Product Change Notification

Change Notification #: 112289 - 00
Change Title: Intel® Server System R2208IP4LHPC
PCN 112289-00, Product Design
Update System Power Supply Bracket,
Printed Board Assembly (PBA),
BIOS/ME/BMC/FRUSDR Firmware and
Standoff
Date of Publication: May 20, 2013

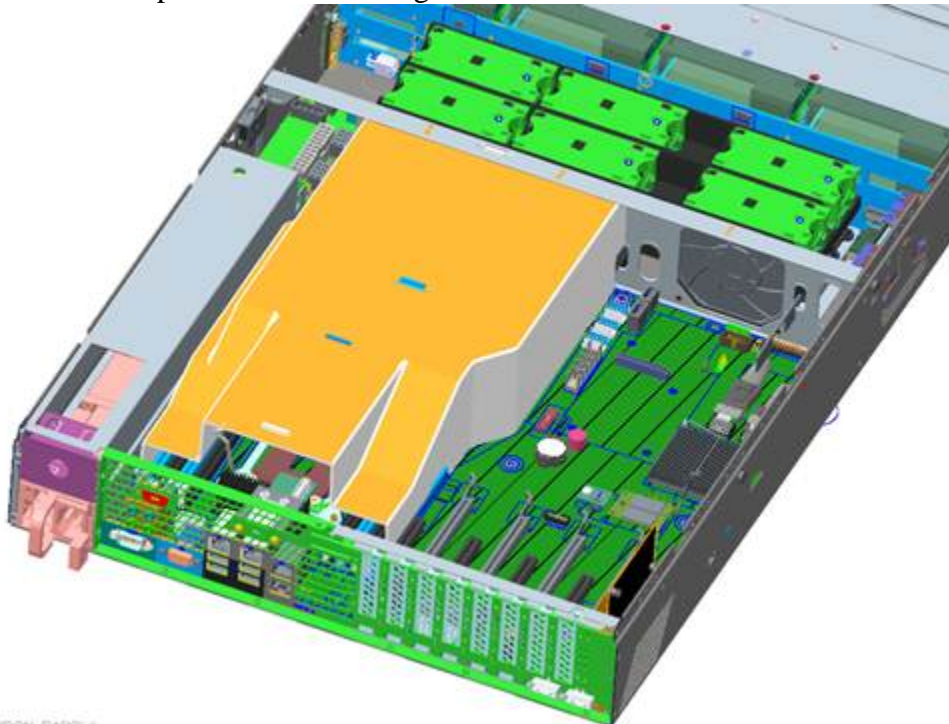
1. The server system chassis power supply bracket has been updated to add a cutout on the top side of the chassis to better fit the power supply module. Please refer to below picture for this change:
